The text reproduced below reflects the state of play of the discussion of the SIG UNR157 up to its 8<sup>th</sup> meeting on raising the specified maximum speed of ALKS up to 130 km/h. It is based on ECE/TRANS/WP.29/GRVA/2020/32 (DE) and subsequent amendments received on this proposal.

Modifications to the existing text of UN-Regulation No. 157 (incl. suppl. 02 to 00 series) are marked in **black bold** for new or ~~struckthrough~~ for deleted characters.

## I. Proposal

Figure 1

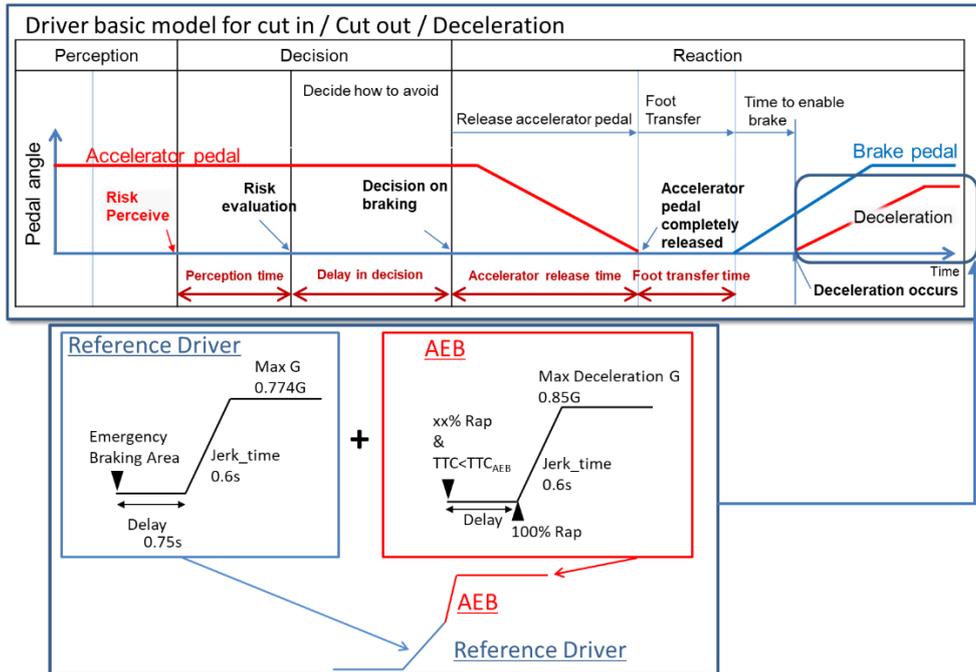
Group conclusion: agreed to amend title of figure accordingly:

~~Skilled~~ Careful Competent and competent careful human performance model

**Figure 6**  
**Flow-chart of the second ALKS performance model for the case of the cut in traffic critical scenario**

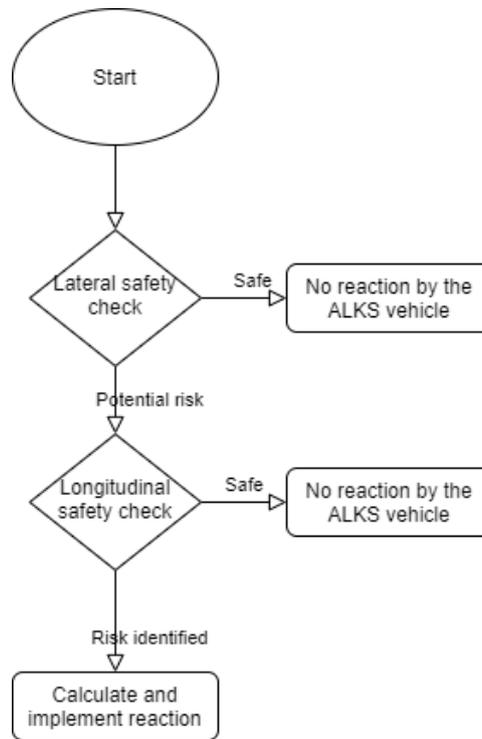
*Group conclusion: amendments proposed by JP (UNR157-08-06) and OICA/CELP (UNR146-08-12) agreed.*

In the second performance model, it is assumed that the driver can anticipate the risk of a collision and apply proportionate braking. ~~apply proportionate braking actions in order to anticipate the risk of collision.~~ In this case, the performance model considers the following three actions performed by the competent and careful human driver: "Lateral Safety Check"; "Longitudinal Safety Check"; and, "Reaction". A Reaction is implemented only if the Lateral and Longitudinal Safety Checks identify a risk of imminent collision. The diagram reported in Figure 2 provides a visual representation of the decision flow followed by the driver in the second performance model for the case of the cut-in traffic critical scenario.
